DATE: April 10, 2014
TO: Planning Commission
FROM: Ryan Hostetter, Senior Planner
SUBJECT: Loperena Coastal Development Permit DRC2005-00216

SUBJECT: Response to Haro, Kasunich, and Associates, Inc., Comments on GeoSoils Inc. March 12, 2014 Report dated 31 March 2014.

Figure 1. Relationship between water depth and breaker height from FEMA.

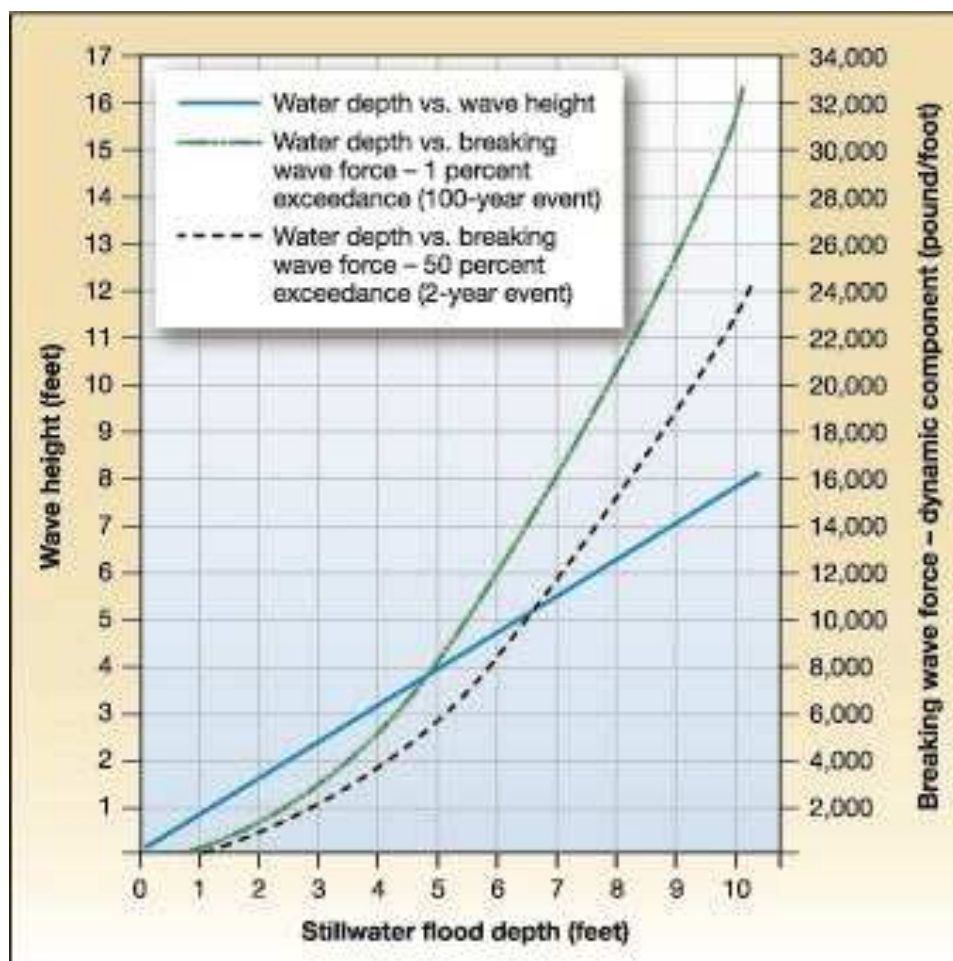
"We note that the prior April 10, 2013 GeoSoils report indicates that with 2.5 feet of future sea level rise the water surface used for wave runup and overtopping analysis will be at an elevation +10.1 feet NAVD88; and the maximum scour elevation at the toe of the rock outcropping (coastal bluff) is at 3.1 feet NAVD88. This yields a water depth of 7.0 feet at the toe of the rock outcropping (coastal bluff), which was used in the 2013 GeoSoils analysis, which used a 5.5 foot high wave at the toe. The "new" March 12, 2014 GeoSoils analysis uses future sea level rise amounts of 4.6 and 5.5 feet respectively, which makes the water surface used for wave runup and overtopping analysis be at an elevation +12.1 and 13.0 feet NAVD88. GeoSoils acknowledges this by using water depths of 9.0 and 9.9 feet at the toe of the rock outcropping (coastal bluff) for the 2014 analysis. They then use 7.0 and 7.7 foot high waves at the toe in the analysis. Larger waves than those they used in their analysis have the potential to occur at the site. Our analysis suggests that wave heights of 8.9 to 9.8 feet could occur at the toe of the bluff and are appropriate. Use of appropriate wave heights would significantly increase wave runup, overtopping frequency and: overtopping volumes at the site. With future sea level rise, deeper water will occur at the toe of the bluff, and larger waves will break there creating higher wave runup; this will result in greater rates of bluff overtopping more frequent wave impact on the proposed home, and more rapid. bluff erosion, which will erode the bluff over time."

We respectfully disagree. The waves that break right at the toe of the rock outcropping will provide the maximum wave runup. The breaker height is depth limited by the depth of the water to the toe of the rock outcropping. The design water elevation was determined using the California Coastal Commission (CCC) Draft Sea-Level Rise (SLR) Policy Guidance document. The CCC method uses the highest recorded water level in the area corrected for future SLR. The bedrock material at the toe of the rock outcropping is very erosion resistant and is not subject to significant down wearing over time. The design water depths dictate the breaker heights. Figure 1 below, taken from the FEMA Coastal Construction Manual (Figure 8-11), shows the relationship between water depth and breaker height (the blue line on the graph). For 9 feet and 9.9 feet of still water depth the breaker height is 7 feet and 7.7 feet respectively.

Waves in excess of these heights can occur offshore of the site and away from the toe of the rock outcropping, but they will always break in a water depth that is about 1.28 times the wave height. Once a wave has broken, the wave bore height is typically less than $\frac{1}{2}$ of the breaking wave height. HKA's analysis was not provided so it is unclear how their analysis suggests 8.9 feet and 9.8 feet high waves at the toe. It is physically impossible for waves of that height to be at the toe of the rock outcropping. It is important to repeat that our analysis is for the most onerous conditions in the future under the highest SLR estimate and the coincidence of the highest tides and larger waves. These conditions represent less than the 1% recurrence oceanographic conditions at the site. Our analysis shows that the proposed development will not be significantly impacted under these conditions.

Figure 2. Wind speed profile near the ground.

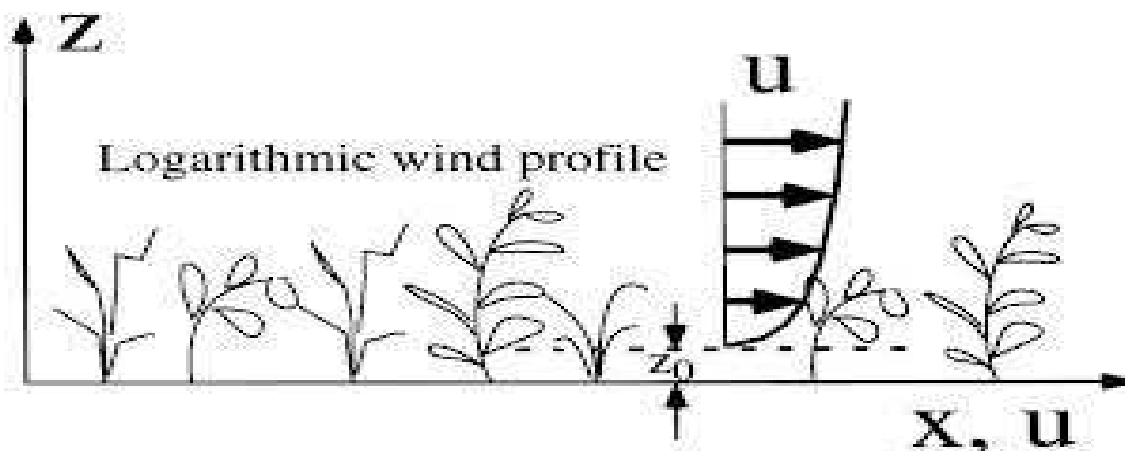
Onshore Wind Velocities of 3.376 feet per second (about 2.25 MPH) were used in the 2014 GeoSoils analysis. Wind velocities of 16.878 feet per second is about 11.6 MPH) were used in the 2013 GeoSoils analysis, closer to actual wind velocities that frequently occur onshore at the site during stormy conditions with large waves. No explanation of why the reduced wind velocity was made. Use of appropriate wind velocities in the 2014 study would significantly increase wave overtopping frequency and overtopping volumes at the site.

We respectfully disagree with the reviewer. The wave runup and overtopping analysis is not measurably influenced by wind speed. This is primarily due to the wind speed profile near the ground (where the overtopping water is flowing). Figure 2 below shows a typical wind speed profile. The wind speed at ground level is very close to 0.0 ft/sec and then the wind speed increases with height above the ground. In as much as the overtopping

water depth is 1 foot or less, the wind does not increase the rate of overtopping. Wind speed is included in the ACES input menu because the ACES analysis suite includes wind wave generation and other coastal processes that are influenced by wind speed. It should also be noted that the methods for determining wave overtopping in the USACE Coastal Engineering Manual does NOT include contributions for on-shore winds. Finally, TABLE III below includes a wind speed of 25 ft/sec (greater than the HKA suggested wind speed of 16.9 ft/sec) and the HKA roughness coefficient for the 5.5 feet of SLR case. The significant increase in the wind speed between TABLE II and TABLE III resulted in an increase of the overtopping rate of only 0.04 ft³/s-ft overtopping rate. This is an insignificant change and not a significant increase in wave overtopping, as stated in the HKA review comment.
